Addendum 02

PROJECT: Fort Loramie Local Schools Athletic Complex Building & Associated Improvements
600 East Park Street
Fort Loramie, Ohio 45845

PROJECT #: 25041.00

This addendum consists of 4 page addendum, 14 pages of exhibits, 4 specification sections and 39 drawing sheets

1 A1.2 **MEZZANINE FLOOR PLAN**
1/8" = 1'-0"

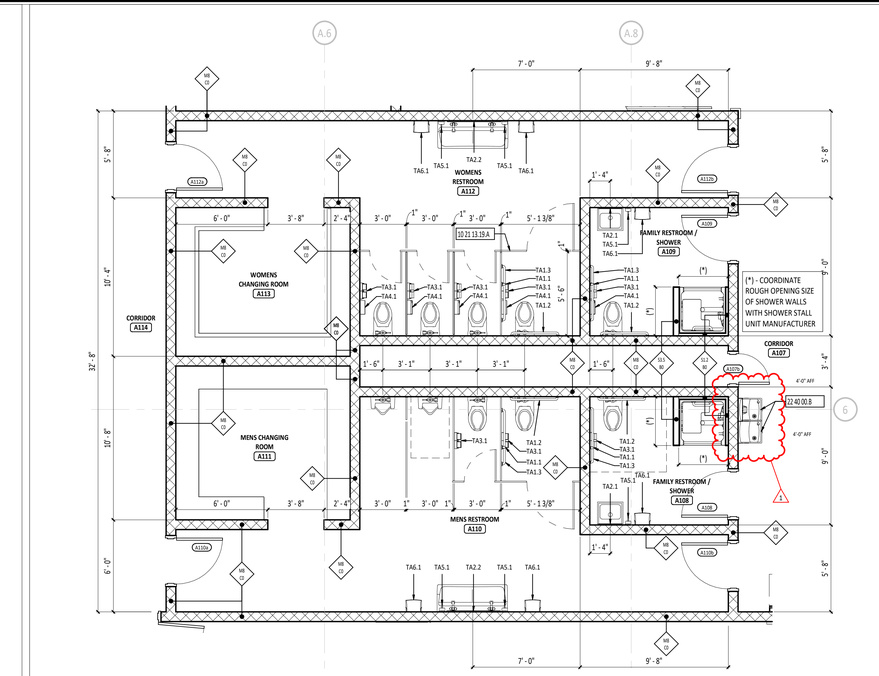
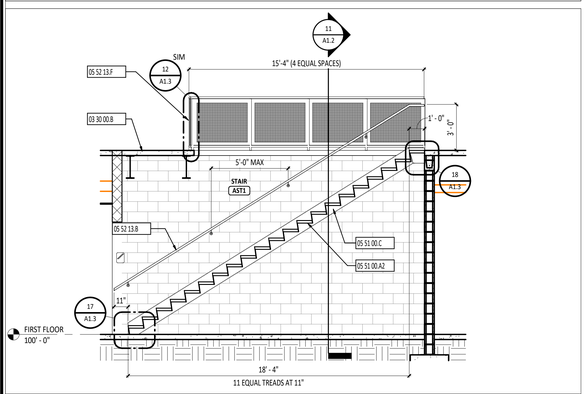
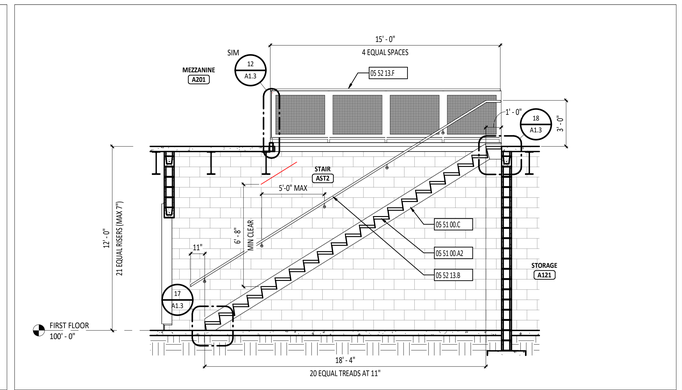
9.) A1.2 Mezzanine and Enlarged Restroom Plans – Remove 4" CMU partial height walls.
10.) A1.3 Enlarged Column, Plan and Stair Details – Modified Detail 12/A1.3 Mezzanine stair opening guardrail detail.

12 A1.3 **GUARDRAIL DETAIL**
1 1/2" = 1'-0"

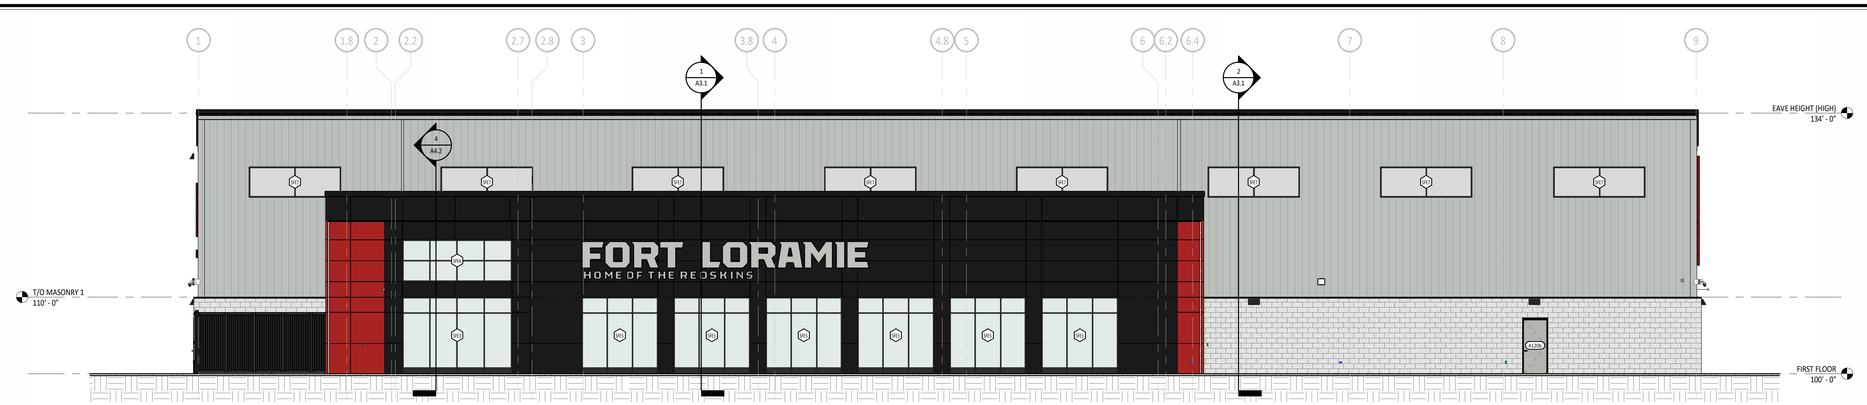
7. Would Superior Aluminum railing for the mezzanine be considered as an alternate?
    a. **Response: Superior Aluminum Series 9M aluminum mesh railing is included as an alternate via addendum 02. Railing must be able to be mounted to the top of the HSS tube steel on the mezzanine edge and at stair openings. All engineering and mounting methods to be done by Superior Aluminum and be submitted for approval.**

SHEET TITLE:
EXTERIOR ELEVATIONS COLORED

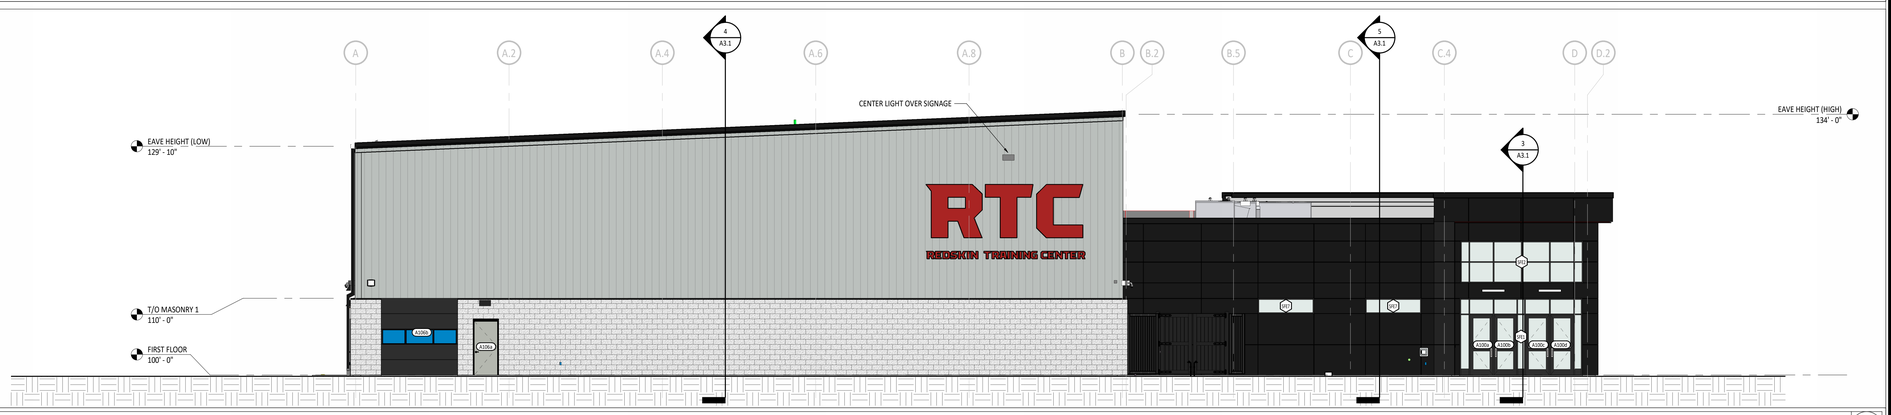
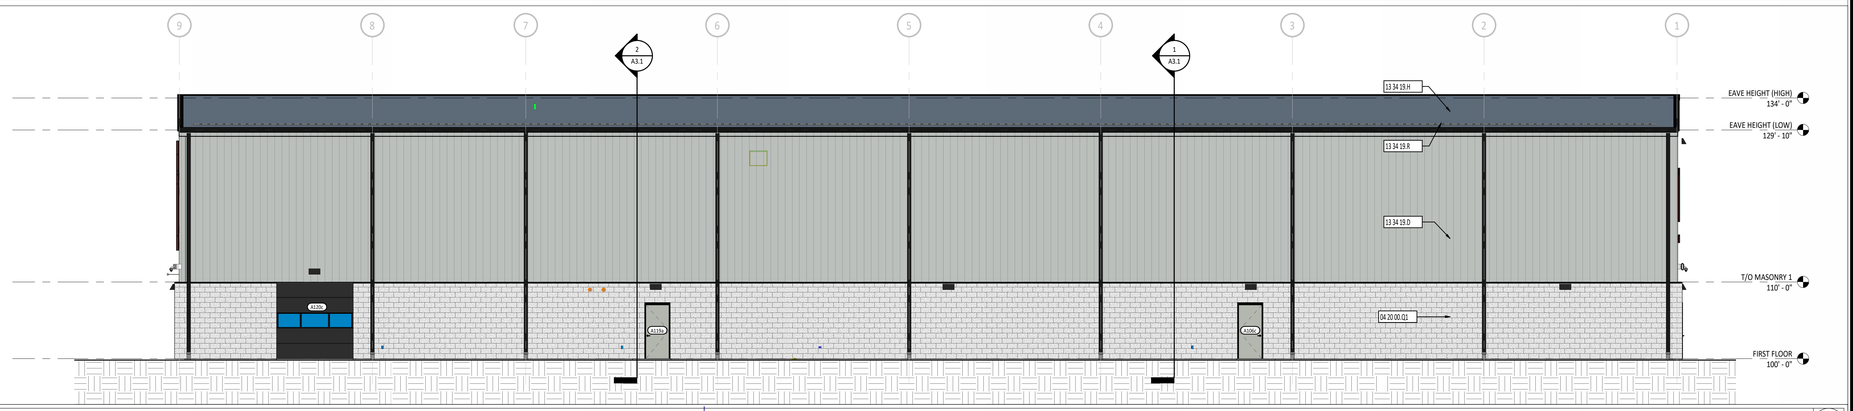
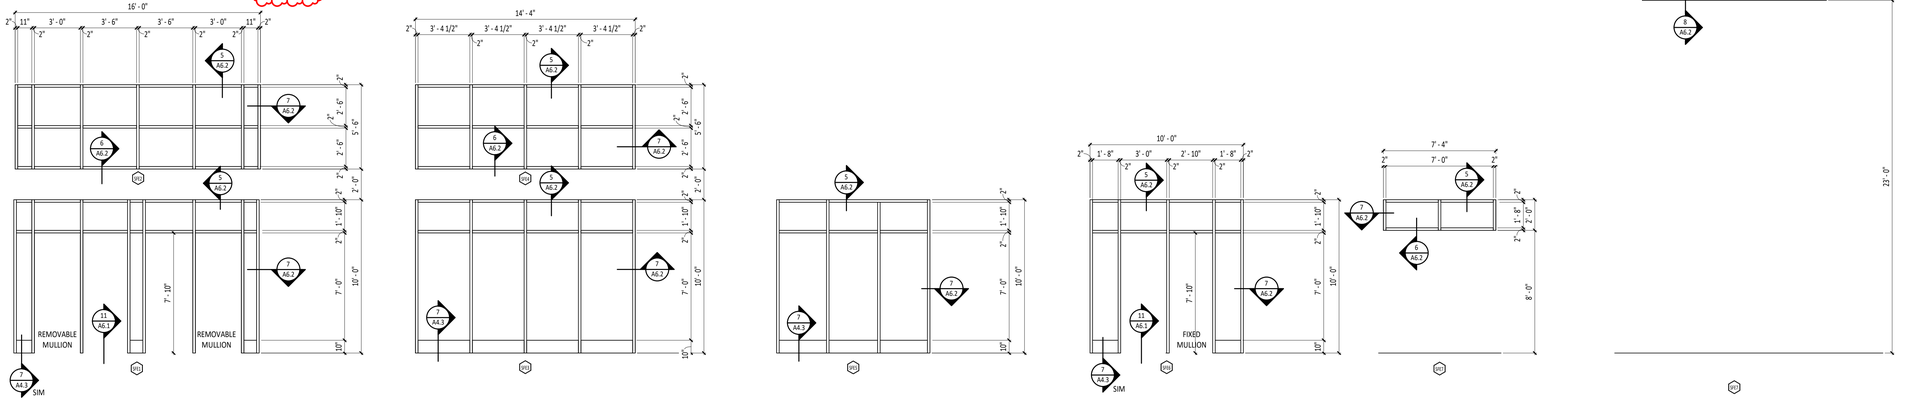
11.) A2.2 Exterior Elevations – Colored – Added sheet to drawing set
12.) A6.2 Storefront & Door Elevations / Details – Added glazing types to the storefront schedules to clarify locations of different glazing. Reference 08 80 00 spec section for descriptions of glazing types.

ENLARGED FLOOR PATTERN PLANS

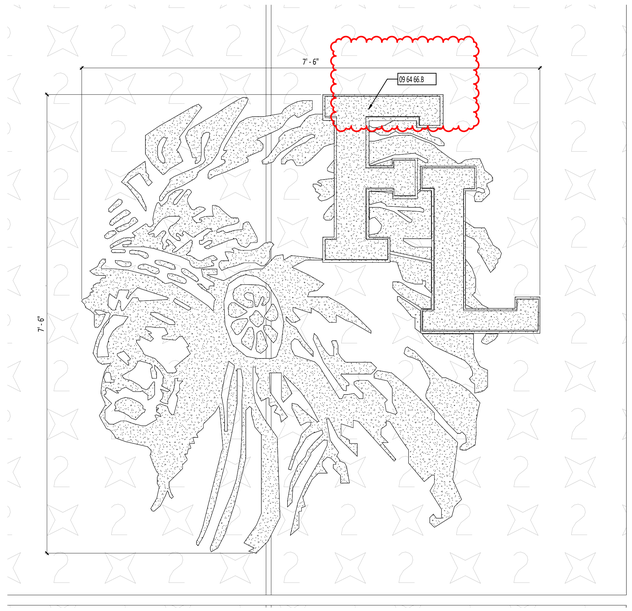
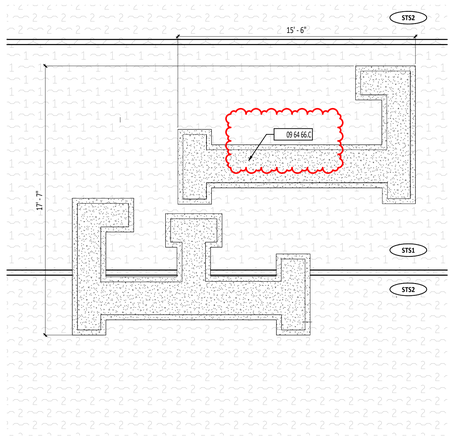
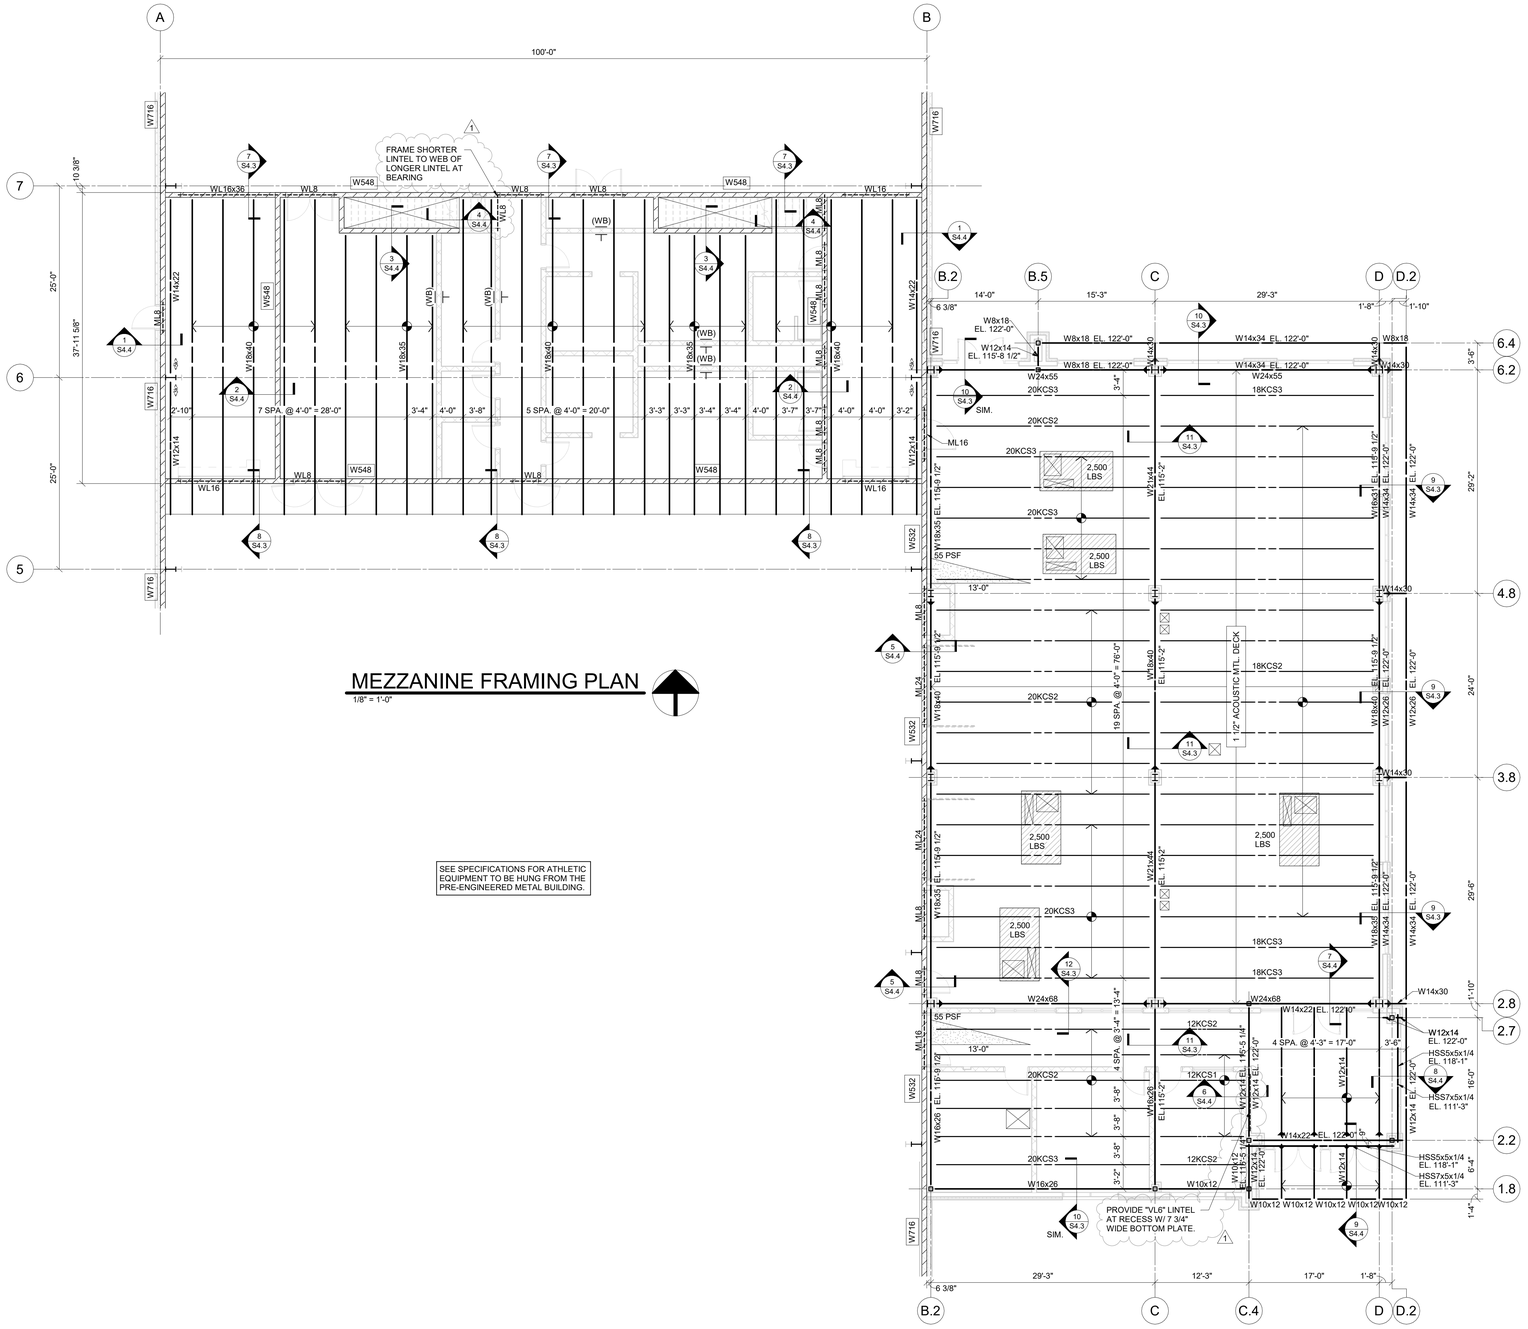
15.) A9.3 – Details 1, 2, and 3 – Revised keynotes and graphic information.
16.) S3.1 Framing Plan - Added a lintel over the entrance to Stair AST1. Added a lintel for the display area in Vestibule A100.

17. For the inlaid platform logos: Do you have a higher quality image of the logo that you can share? Do you have specific colors that you want to use? Overall dimensions of the platform?
    a. **Response: Logos available upon request, reference 4/A9.3 for dimensions and colors**

1 P1.2 **SITE PLUMBING PLAN**
1" = 20'-0"

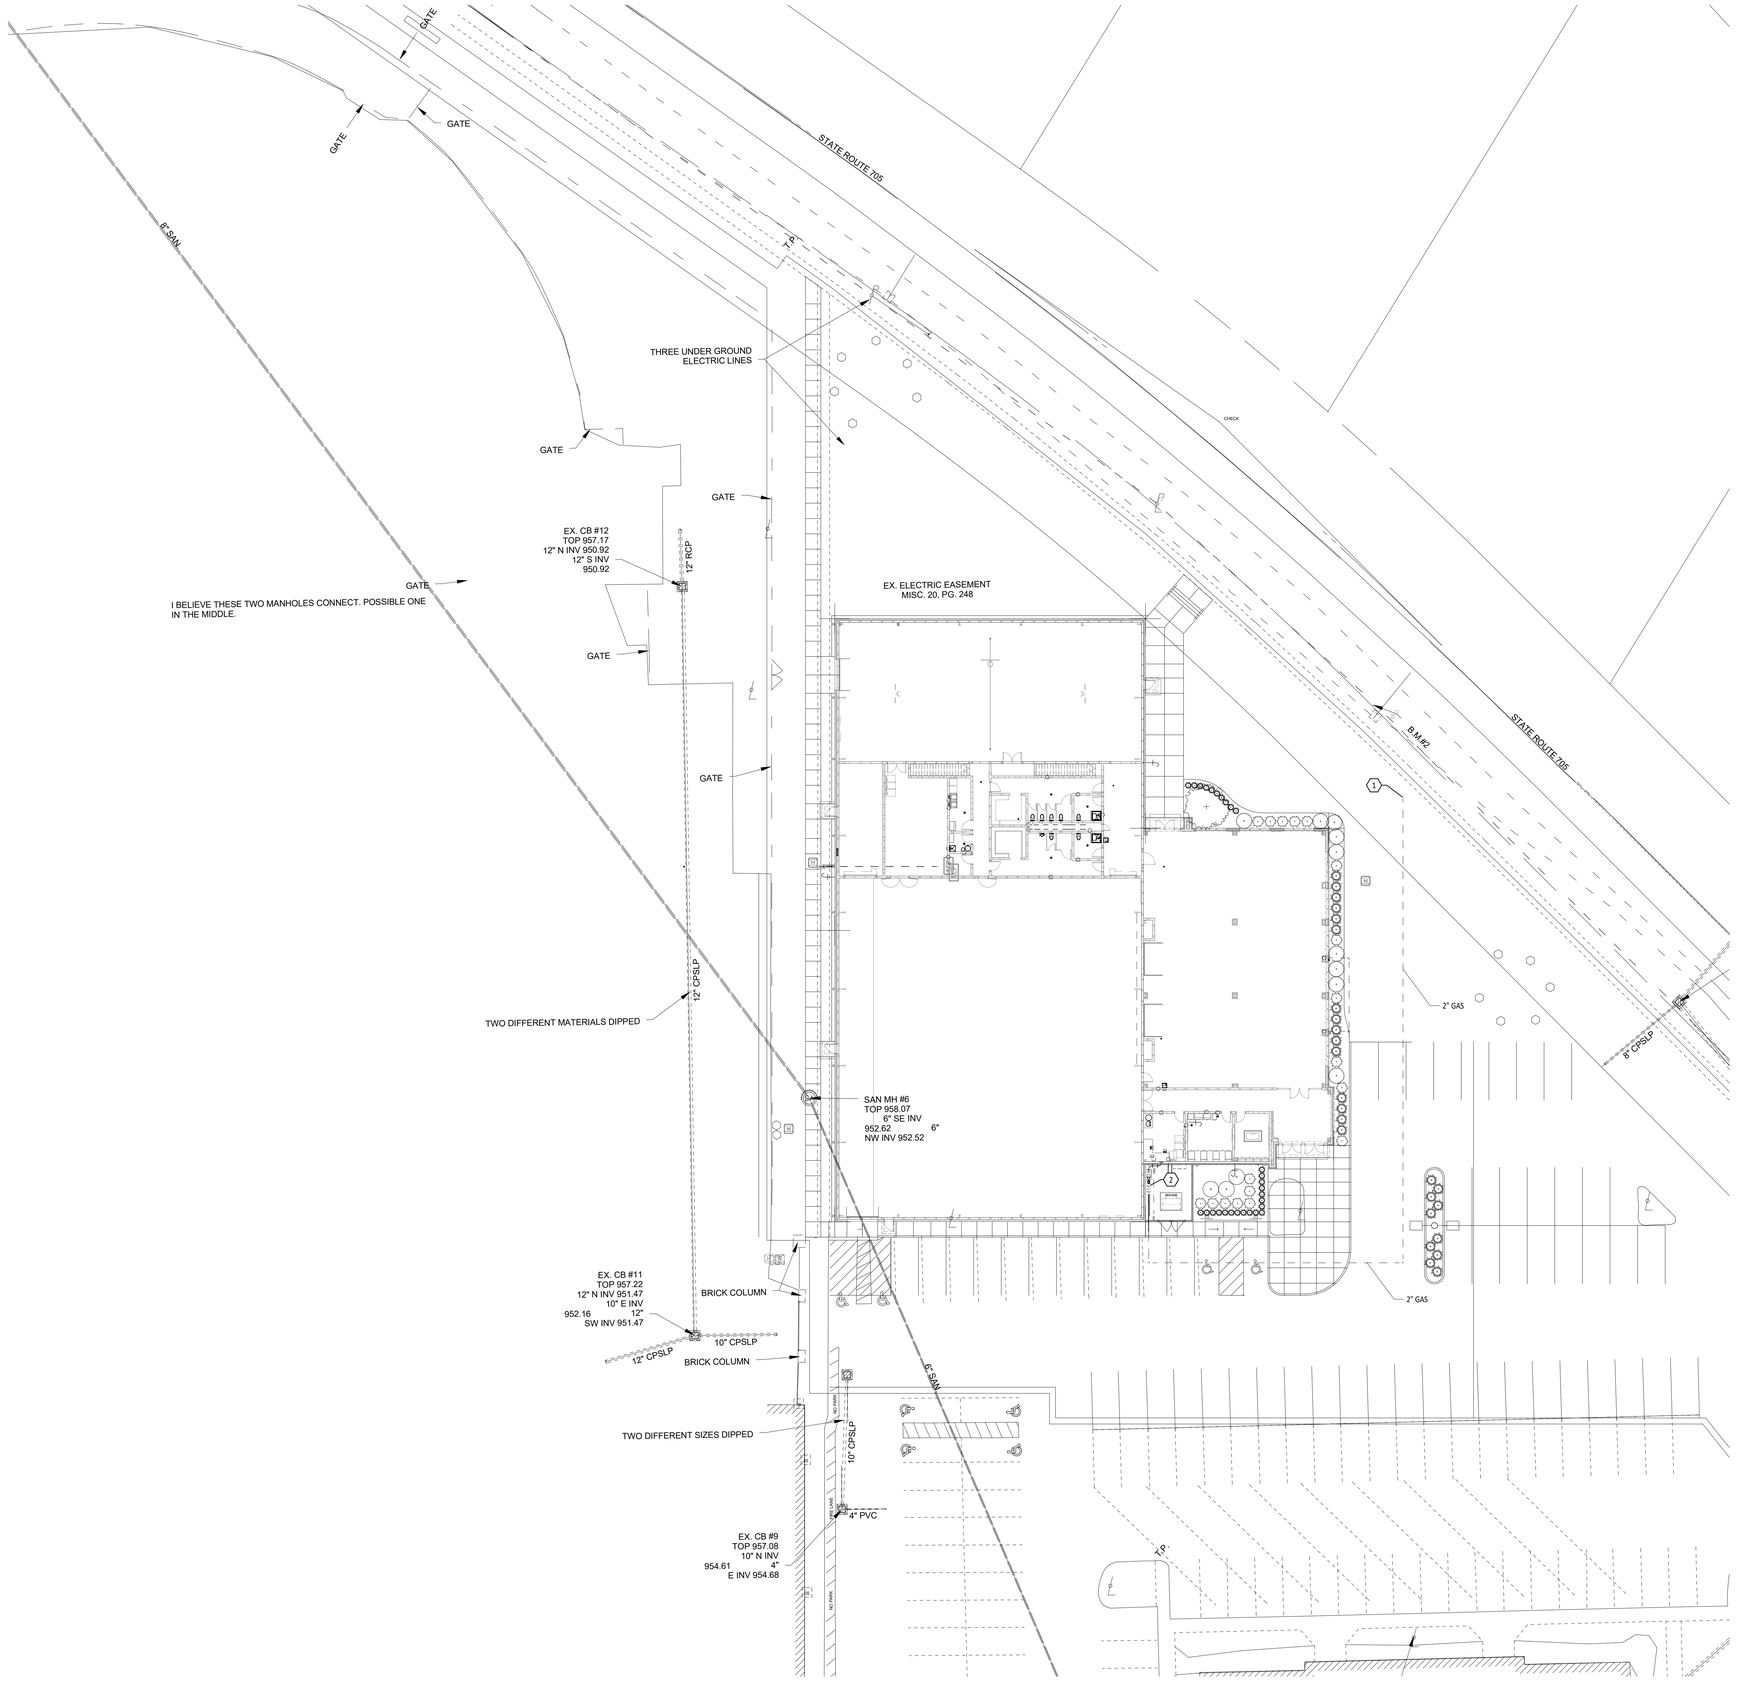
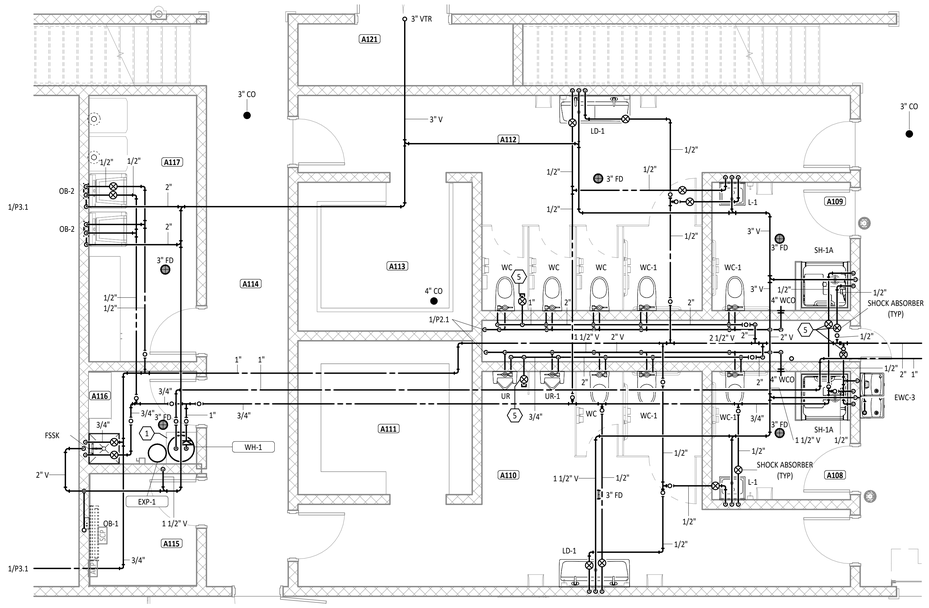
19.) P1.2 Site Plumbing Plan – New sheet showing site gas piping.
20.) P4.1 Enlarged Plumbing Plans – Move vent through roof to avoid ductwork. Reroute water cooler water and vent piping to minimize pipe in the corridor.
